**SUBJECT : Hyundai ImageQuest Co., Ltd.**  
**FCC ID: PJILT17AW000**  
**FCC Part 15 Subpart B Certification**

**Model No. / Type No.: HQL170WR / LT17AW000**

## • Solution for EMI

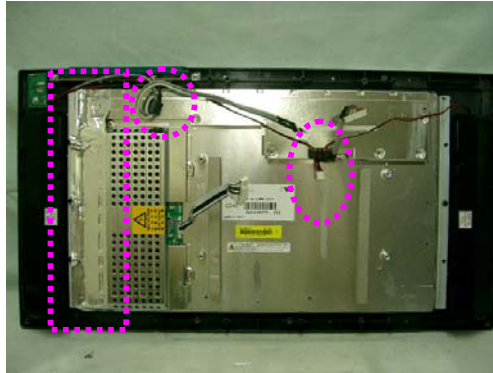
1. Attach aluminum foil on the mainframe and LCD panel frame.  
And Apply a ferrite core to the audio, video and OSD board signal cable.

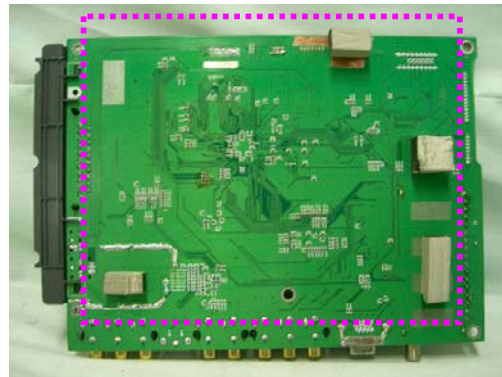
2. Attach a gasket on the main board.

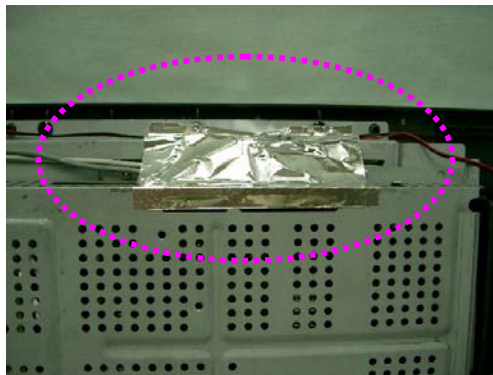
3. Attach aluminum foil on the mainframe cover for OSD and audio signal cable fixed.
